Product Change Notification / NTDO-27IGXA459

CCB 4649.001 Final Notice: Qualification of MMT as an additional assembly site for selected 24LC256T, 24AA256T and 24FC256T device families available in 8L TDFN (2x3x0.8mm) package.

**PCN #: NTDO-27IGXA459**

**CCB 4649.001**  
**Pre and Post Change Summary**  
**PCN #: NTDO-27IGXA459**

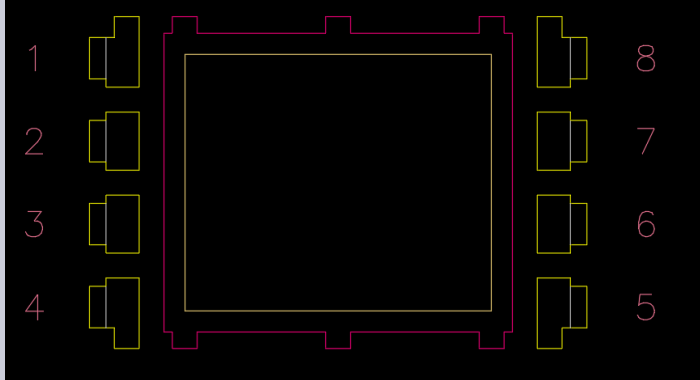
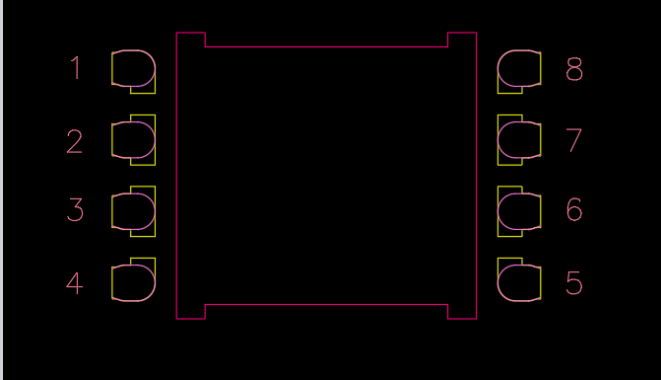
# LEAD FRAME COMPARISON

UTL3	MMT
Lead-Frame		
Lead-Frame Material	C194	A194
Lead-Frame Paddle Size	83 x 71 mils	83 x 71 mils
DAP Surface Prep	PPF	PPF

*Note: \*C194, A194 or CDA194 Lead frame material are the same, it is just a MCHP internal labelling difference.*
